Harnett County Government Complex
307 Cornelius Harnett Boulevard
Lillington, NC 27546

Tingen Point
#08-5-20785 Lt 83
#08-5-20786 Lt 82

Re: Status of Improvement Permit Application

Lot # 83

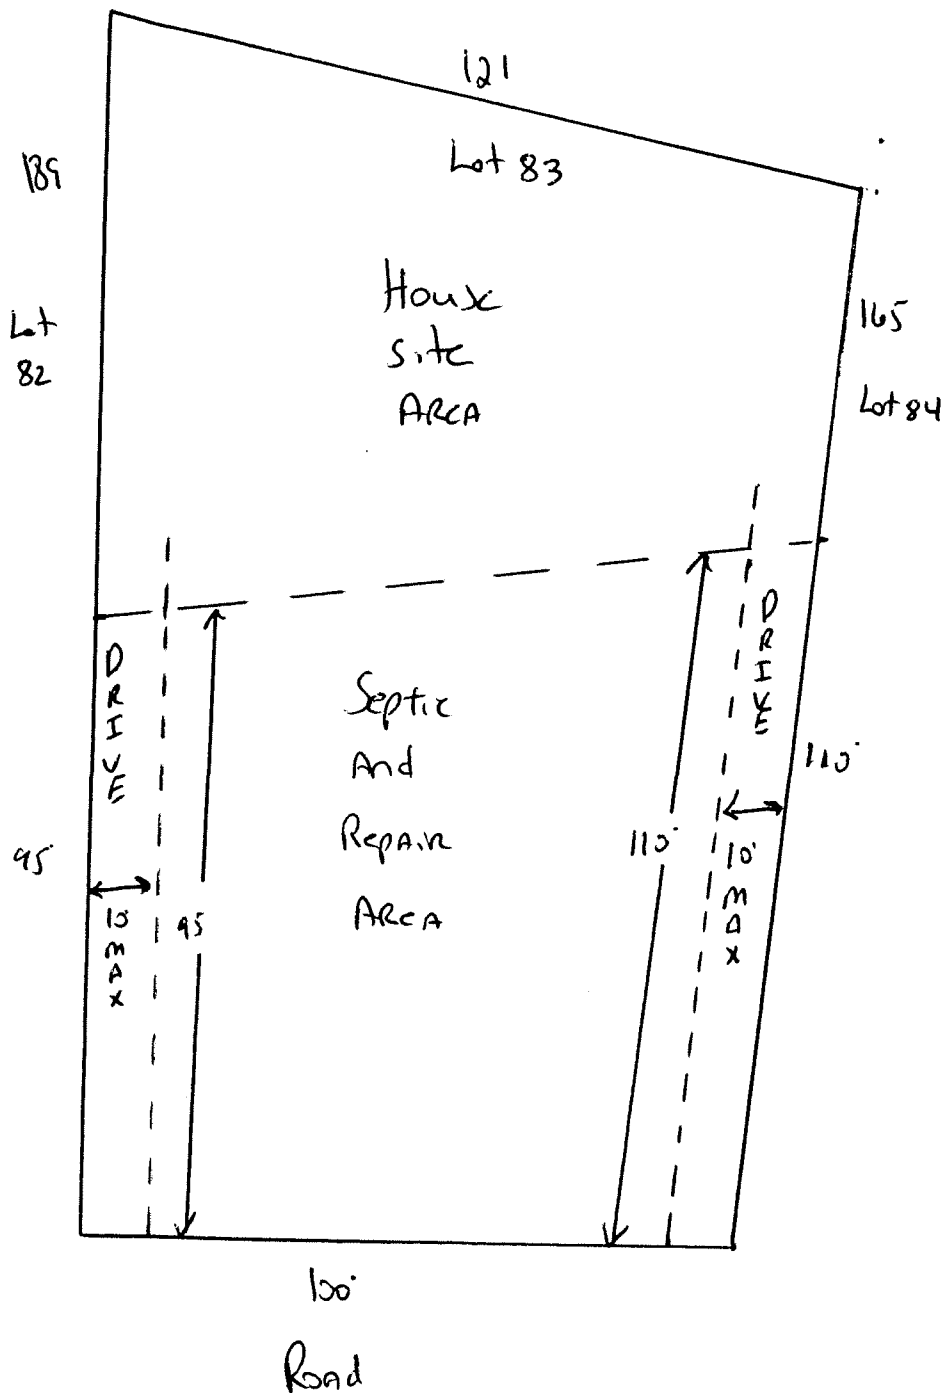
- 1. Property lines/corners not marked or labeled (*\$25.00 fee incurred*)
- 2. House corners not marked or labeled (*\$25.00 fee incurred*)
- 3. Directions not clear to property (*\$25.00 fee incurred*)
- 4. Property needs brush or vegetation removed
- 5. Backhoe pits required
- 6. Other – Move homes as shown and submit new plot plans to Central Permitting.

NOTE: That home must be at least 95' from front property line (Along 82/83 Property line) and 110' from front property line (Along 83/84 Property line)

NOTE DRIVE must be along either Property line as shown - Drive to be at a max of 10' wide

Lot 82 Tinsjen Pointe

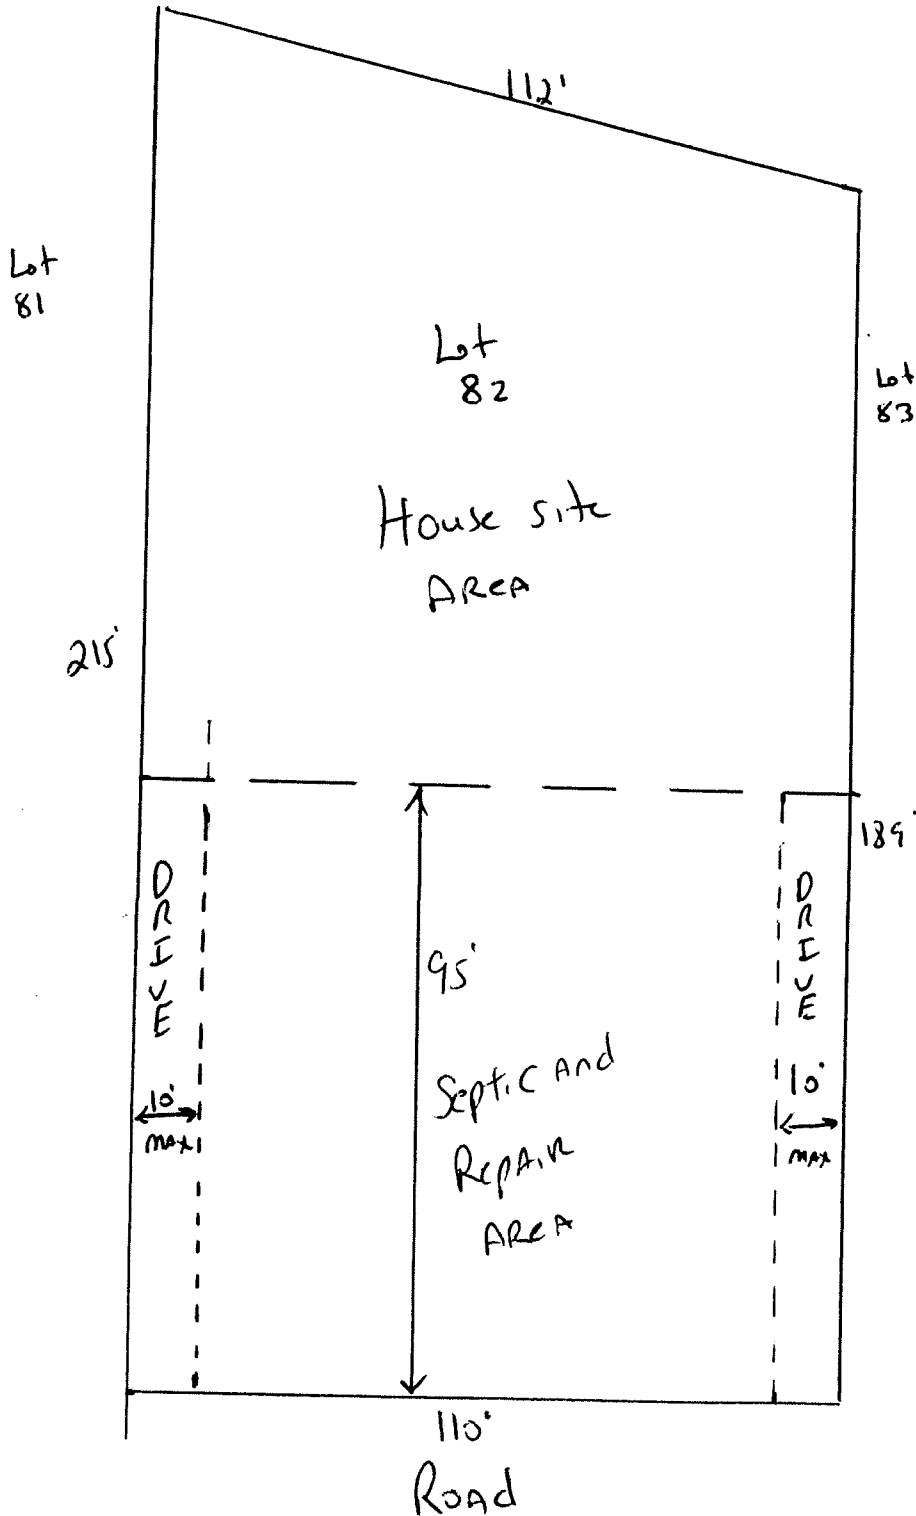
NOTE: Home must be
At least 95'
From Front
Property Line

DRIVEWAY can be
along either
Lot 81/82 Property
Line or Lot 82/83
Property Line
DRIVE TO BE A
MAX OF 10' wide
until DRIVE PASSES
95' from Front
Property Line
